## Manitoba Hydro International's Review of the Muskrat Falls and Labrador Island HVdc Link (LIL) and the Isolated Island Options

Prepared for:  
**Hon. Jerome Kennedy, Q.C.**  
The Minister of the Department of Natural Resources  
Government of Newfoundland and Labrador

July 2012

# 1 HVdc, Electrode<sub>1</sub> and Collector Transmission System Review

Figure 2: Typical HVdc **Transmission Guy Tangent** Structures

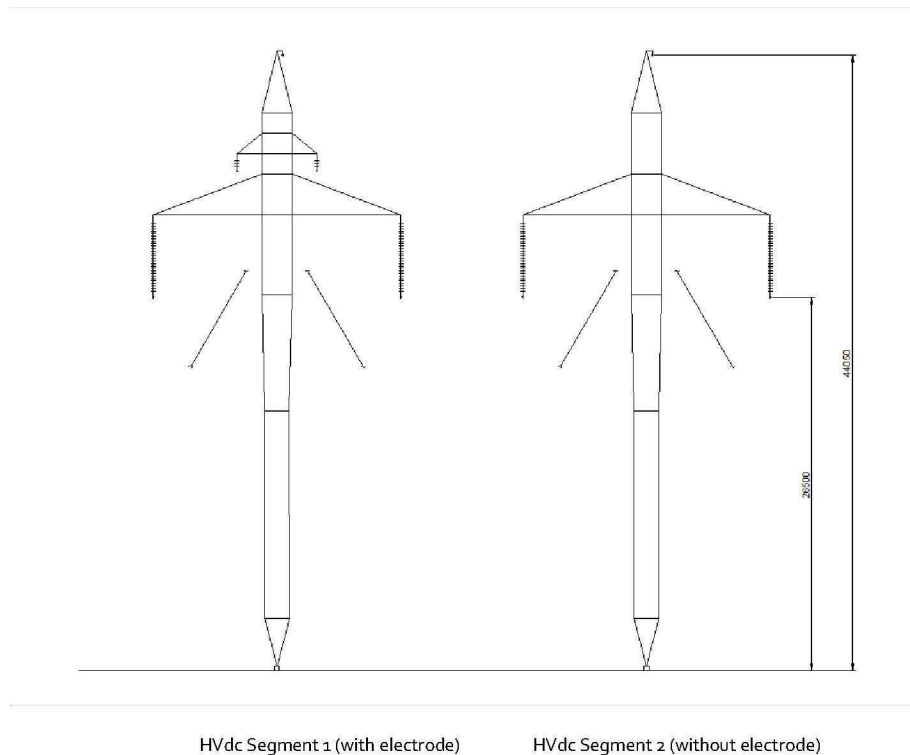
**Comment [plw5]:** Gerry, please specify tower width, extend the guys and specify that width, and note the units.

**Comment [plw6]:** Gerry, please confirm this number.

Figure 3: Design Spans for Ice Loading

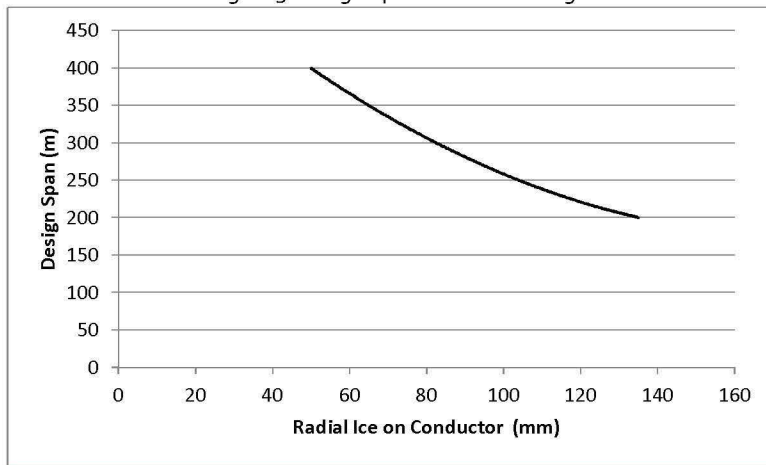
**Comment [plw7]:** Gerry, can you please send me the original so I can reformat the presentation.
